TECH NOTES

TECH NOTE # TN95 - 1

RE-ISSUE: '59 BASSMAN
'63 VIBROVERB
'65 TWIN REVERB
'65 DELUXE REVERB

GROUND POLARITY SWITCH SCHEMATICS

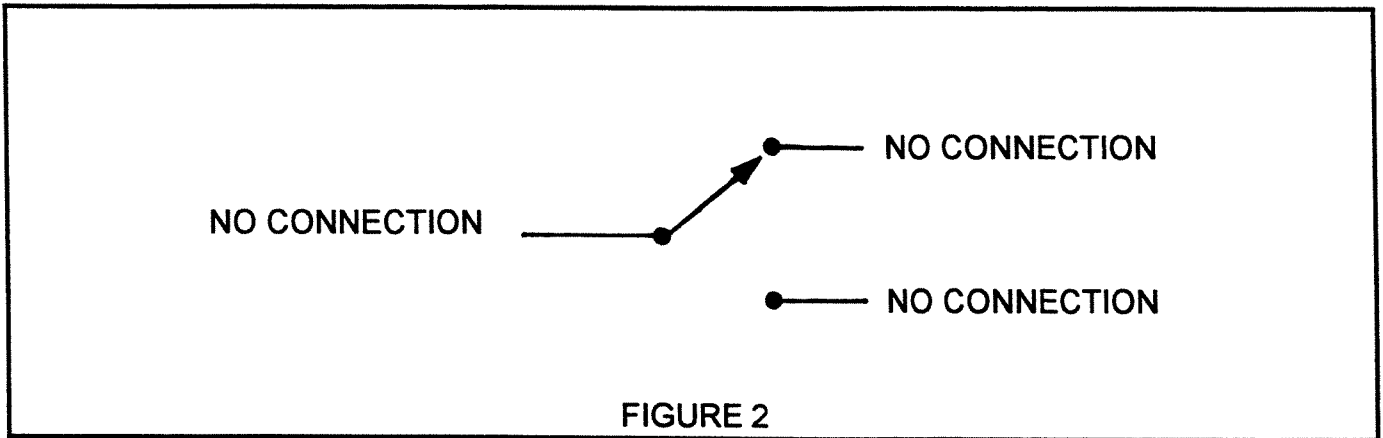
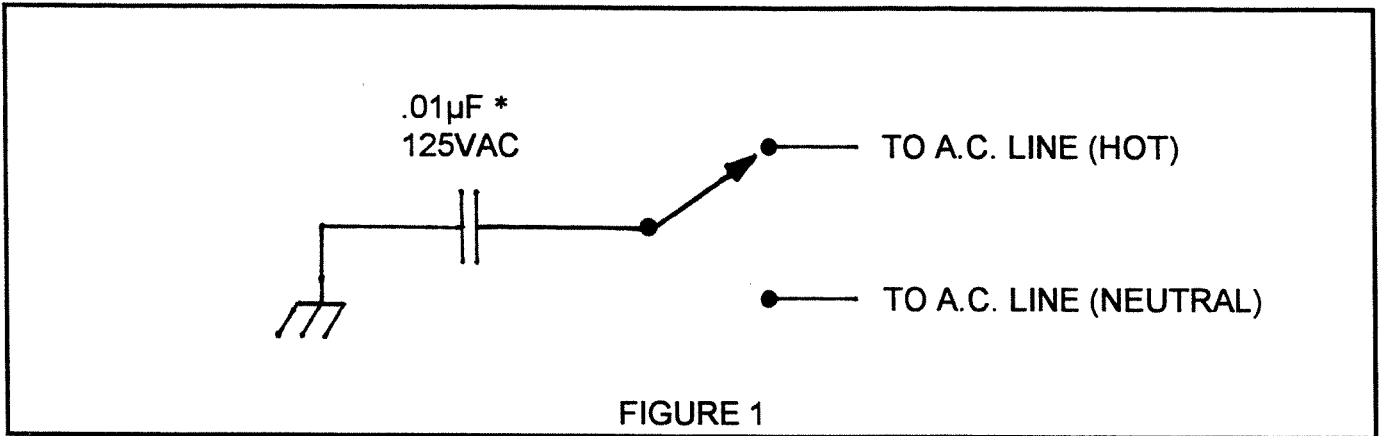
A special capacitor that is approved by the safety regulatory agencies (U.L. listed E33628, C.S.A. listed 32208) for use in the ground polarity circuit, is no longer used. The "Dummy" ground switch is installed because it existed on the original versions of re-issue amplifiers. The circuit is unnecessary because all re-issue amplifiers now use a 3 wire power cord. The chassis is connected to earth ground via the 3rd wire. Therefore using the capacitor to reference the chassis to one or the other side of the AC line is not required, nor recommended on units with the 3 wire power cord.

THE CIRCUIT IN FIGURE 1 WAS USED IN AMPLIFIERS PRIOR TO FEBRUARY 1994.

THE CIRCUIT IN FIGURE 2 APPLIES TO AMPLIFIERS MANUFACTURED AFTER FEBRUARY 1994.

If the capacitor is missing and the switch is not wired, DO NOT install a capacitor, or wire the switch.

NOTE: Existing field schematics indicate the presence of the capacitor and the wiring to the switch. This does not apply to current products. See schematics on reverse.
